## PIC16C74A Rev. A Silicon Errata Sheet

The PIC16C74A (Rev. A) parts you have received conform functionally to the Device Data Sheet (DS30390E), except for the anomalies described below.

**FIGURE 1: SCK PULSE VARIATION USING TIMER2/2**

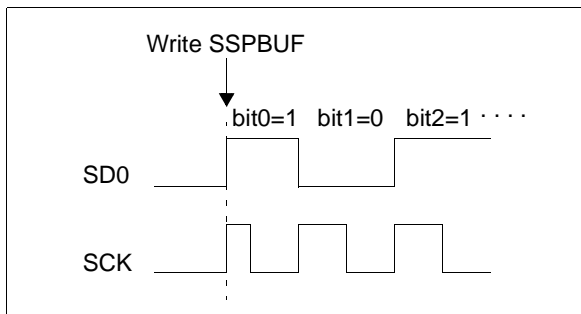
When the SPI is using Timer2/2 as the clock source, a shorter than expected SCK pulse may occur on the first bit of the transmitted/received data (Figure 1).

To avoid producing the short pulse, turn off Timer2 and clear the TMR2 register, load the SSPBUF with the data to transmit, and then turn Timer2 back on. Refer to Example 1 for sample code.

**FIGURE 1: WRITES TO TIMER1 (EXTERNAL CLOCK/OSCILLATOR MODE)**

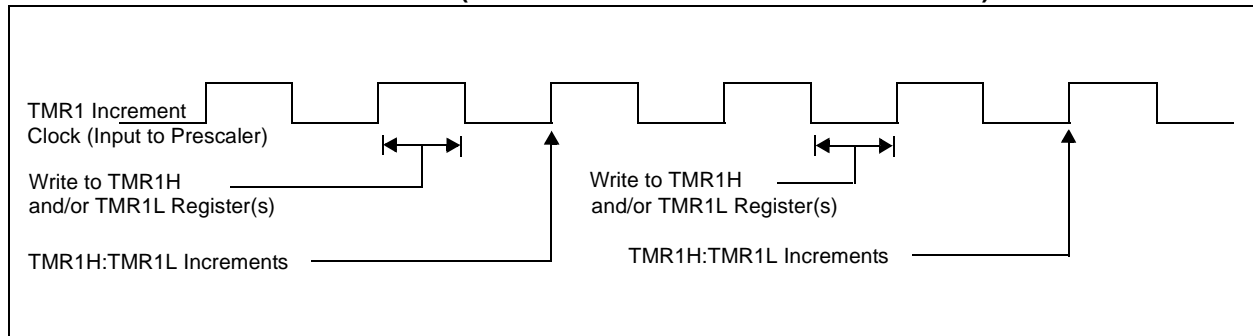
The operation of Timer1 needs some clarification when the timer registers are written when the TMR1ON bit is set.

The internal clock signal that is the input to the TMR1 prescaler affects the incrementing of Timer1 (TMR1H:TMR1L registers and the Timer1 prescaler). When the Timer1 registers are NOT written, the Timer1 will increment on the rising edge of the TMR1 increment clock.

When the TMR1H and/or TMR1L registers are written while this clock is high, TMR1 will increment on the next rising edge of this clock.

When the TMR1H and/or TMR1L registers are written while this clock is low, TMR1 will not increment on the next rising edge of this clock, but must first have a falling clock and the rising clock, for TMR1 to increment.

Figure 1 shows the two cases of writes to the TMR1H and/or TMR1L registers. Due to the V<sub>IH</sub> and V<sub>IL</sub> thresholds on the oscillator/clock pins, external Timer1 oscillator components, and external clock frequency, the Timer1 increment clock may not be of a 50% duty cycle.

The TMR1 increment clock is out of phase of the T1OSO/T1CKI pin by a small propagation delay.
